**Addendum Number Three**

**BOOT BARN WAREHOUSE EXPANSION**

Issued: August 27,2019

**HANNEY & ASSOCIATES ARCHITECTS**

### 1.6 Scored CMU

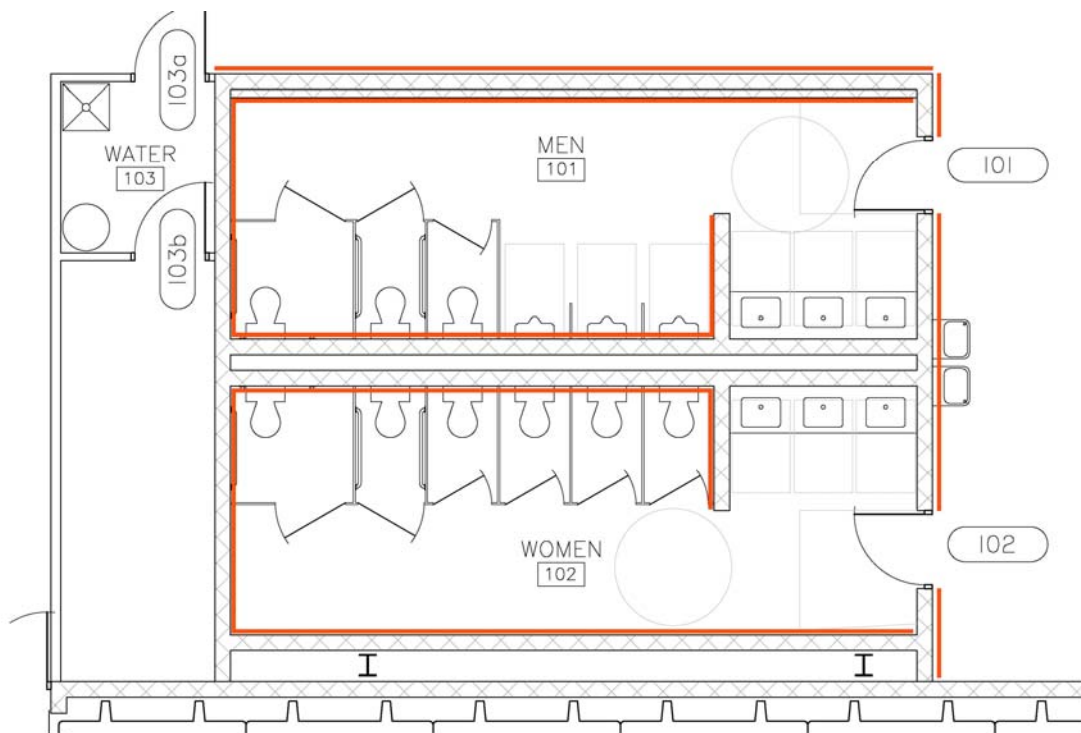
The red line indicates the locations of the scored CMU.

Please note that I have added a 4” layer of CMU on the inside face of the Men’s room to allow for the scored look on both sides of that wall.
